# City of Santa Fe, New Mexico

# memo

**2025-011230-HDRB, 527 Agua Fria St. units 1, 2, & 3,** Westside-Guadalupe Historic District, Significant, Osage Design Studio, agent for Neirika, LLC, owner, proposes to construct a 36 sq. ft. addition, replace windows and doors, raise two sections of roofing, re-roof, stucco, and other repairs. Exceptions are requested to 14-5-2(D)(5)(a)(i)(ii)(iii) for replacement of windows on primary facades, 14-5-2(D)(3)(a) for raising the roof of a significant structure, 14-5-2(D)(2)(c) placing an addition on a primary façade, 14-5-2(D)(5)(b) replacing a chimney on a significant structure.

Figure 3: Window Schedule

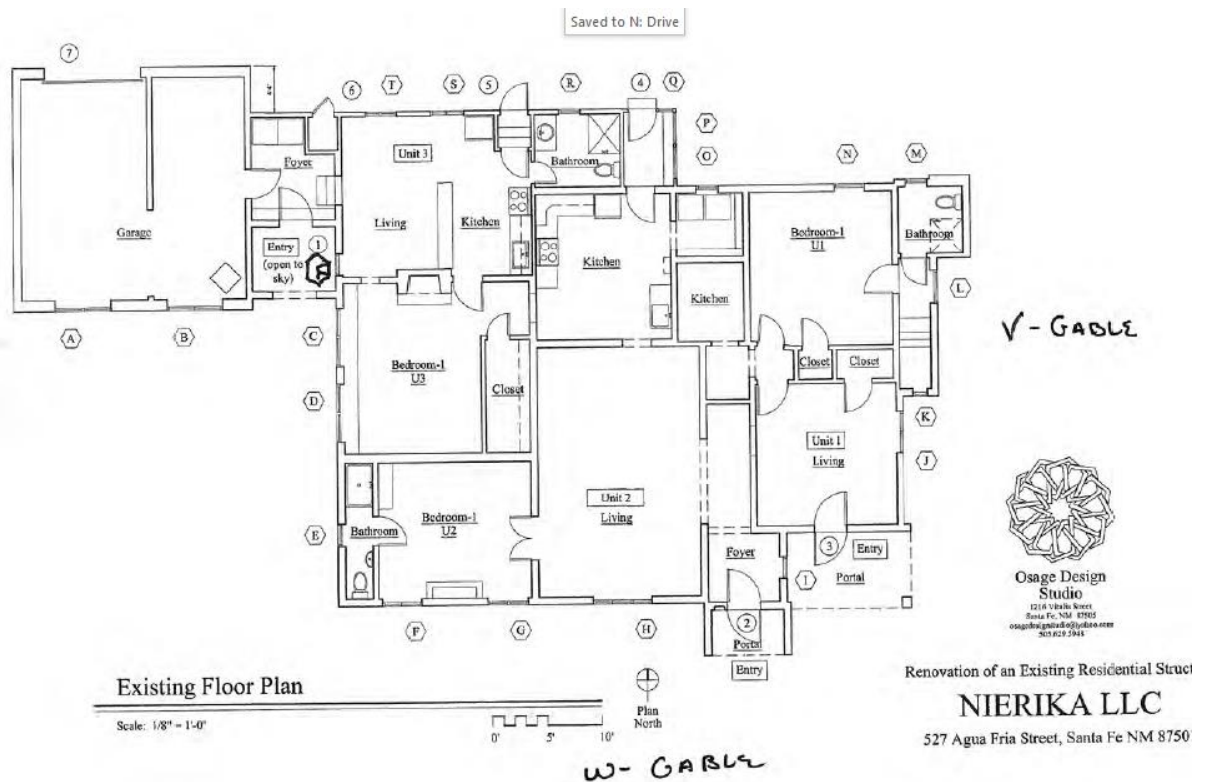
Staff Response: Staff finds that this criterion is not met. Size changes are being requested by requesting the infill of a window and changing windows to doors, and so forth. Alterations of the sizes of the windows in mass on the primary north façade, publicly visible or not, damage the status of the building and therefore the district.

Staff Response: Staff finds that this criterion is not met. Window replacement for the non-historic windows, L, M, P, R, S, T, and V, which are non-historic, and the irreparable historic window O can be considered in part because these windows are non-historic, irreparable, and will be replaced in the same size openings.

Window replacement for the historic windows F, G, H, I, J, L, M, O, P, R, S, T, and V, which can be repaired; repair is not under consideration in this application. According to the window assessment rating, these historic windows are in satisfactory condition and, therefore, are repairable. There is no hardship in retaining these windows.

Replacing the diamond vents changes the style of the home. Diamond-shaped gable vents for the side of a house were popular in the Victorian era and in Mediterranean-style buildings. They offer decorative appeal and attic ventilation, blending both aesthetic and functional purposes, particularly in architectural features. Metal louvered vents will not match the style of the residence.

Replacement of the non-historic doors can be considered. However, the front door that arcs at the top to match the portal is unique and a part of the character of the building. The door shape should be retained.

1. Staff finds that the exception criteria have not been met and recommends denial of the exception to section 14-5-2(D)(5)(a)(i)(ii)(iii) for replacement of historic windows on

Figure 4: Area of Roof to be Raised on East Elevation

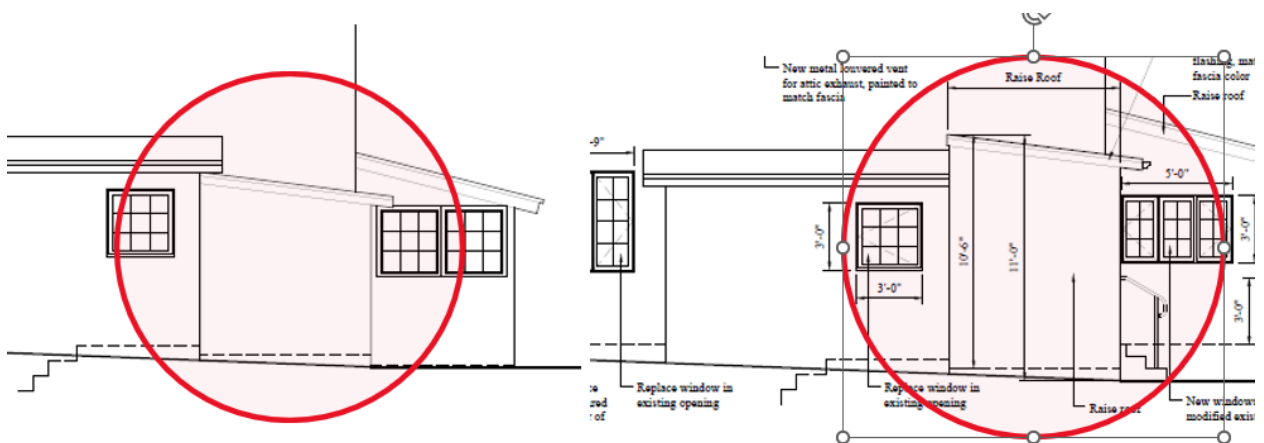
Staff Response: Staff finds that this criterion is not met. Part of the significance of the residence is its various heights. To alter this significant structure may damage the character of the district.

Staff Response: Staff finds that this criterion is not met. The ceiling heights do meet the code requirement for sloped roofs. The code for sloped roofs is an exception to the portion of the code offered. Section R305 of the 2021 International Residential Code reads:

Additionally, the residence was constructed in 1912 and has been habitable for the past 114 years. The raised roof may provide additional comfort, but is not necessary by code or habitability.

Staff Response: Staff finds that this criterion is not met. Raising the roof of the unique structure will alter the significance of varying roof heights and therefore weaken the character of the city.

Figure 6: Area of Addition on North Elevation

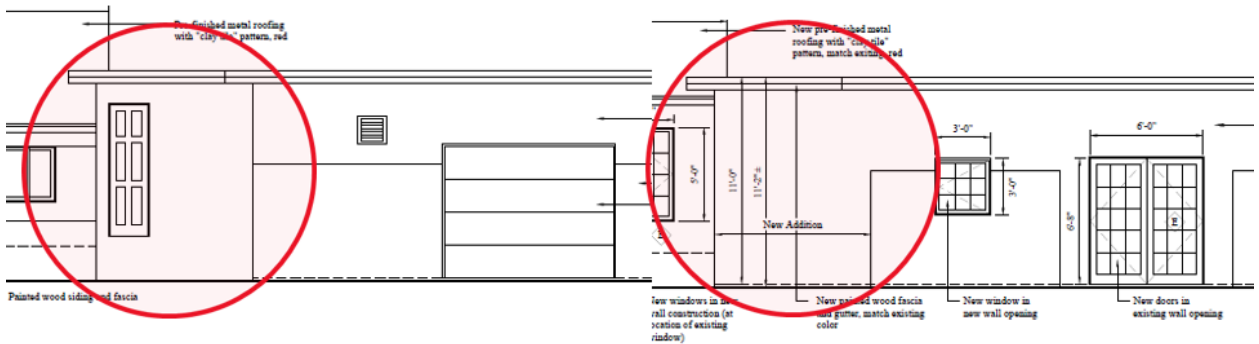
Staff Response: Staff finds that this criterion is not met. The addition as designed is not distinguishable from the original structure, giving a false sense of history which is contrary to the code section 14-5.2(D)(2)(a) which reads: “*Additions shall have similar materials, architectural treatments and styles, features, and details as the existing structure, but shall not duplicate those of the existing structure in a manner that will make the addition indistinguishable from the existing structure.*”

Furthermore, the addition meets the height of the connecting section of roof where the code specifically states that additions shall be differentiated by a minimum of 6”; Section 14-5.2(D)(2)(e)(i) “*For significant and landmark structures shall be a minimum of six (6) inches less than the parapet or equivalent roof-feature of the existing adjacent connecting facade.*”

Staff Response: Staff finds that this criterion is not met. This residence was constructed as a single-family home, not designed to have an adjoined guest house, but a garage unit. The home was constructed in 1912 and was not constructed to meet today’s fire code. Fire code requirements on the historic structure should be confirmed with the Fire Marshal.

Staff Response: Staff finds that this criterion is not met. Under the previous criterion for hardship, the applicant states that they could consider another design option, but have chosen not to because they prefer this option for the “logical separation between the units”. This structure was designed as a single-family residence, not intended to have an adjoined guest house. If another design can be considered in order to avoid adding to a significant structure and impacting the status, district, and city with an alteration, then it should be considered.

Figure 7: Area of Chimney on North Elevation

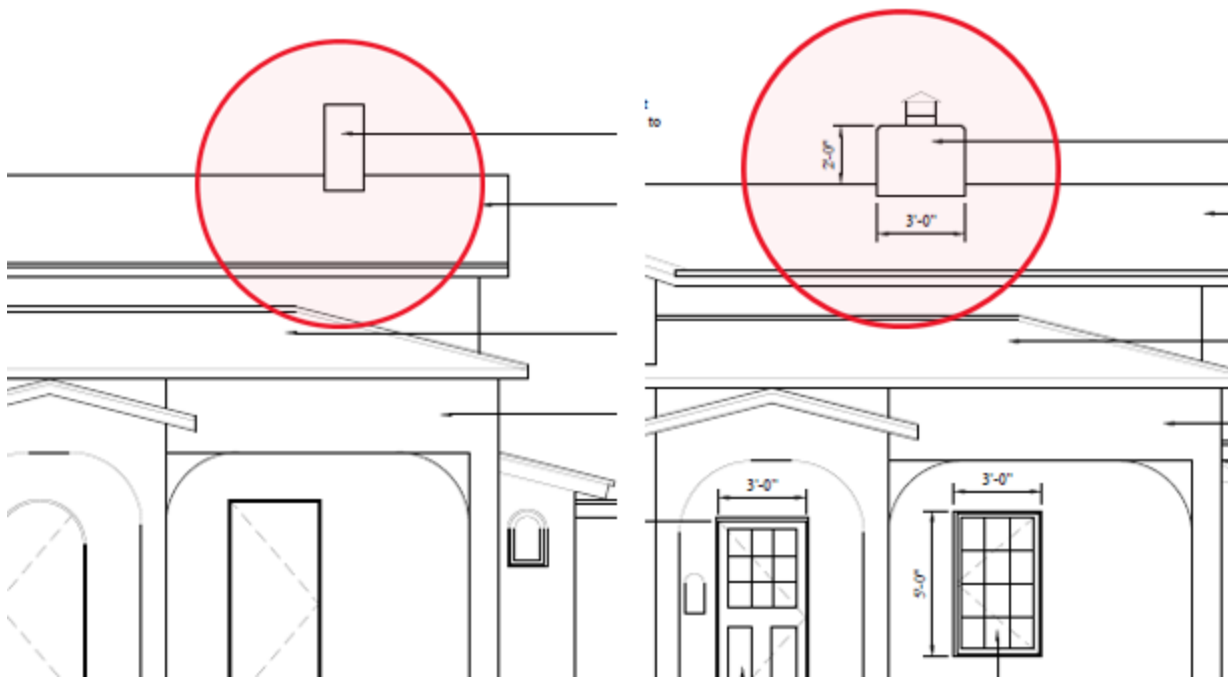
Staff Response: Staff finds that this criterion is met. The existing chimney is not currently connected to an interior fireplace. To install a fireplace and use the chimney, the fireplace will be required to meet current code. Retaining a chimney that is close in appearance, if not in size, will not damage the character of the district.

Staff Response: Staff finds that this criterion is met. When installing a new fireplace, the chimney must come into compliance with the current building code. Per International Building Code section 2113.10 “**Wall Thickness.** *Masonry chimney walls shall be constructed of concrete, solid masonry units, or hollow masonry units grouted solid with no less than 4 inches nominal thickness.*” The historic chimney on the residence does not meet this code requirement and will need to be replaced for the residence to house a fireplace.

Staff Response: Staff finds that this criterion is met. The chimney is an existing feature that will be retained even if replaced for current code compliance, and ensures the continued use of the residence.
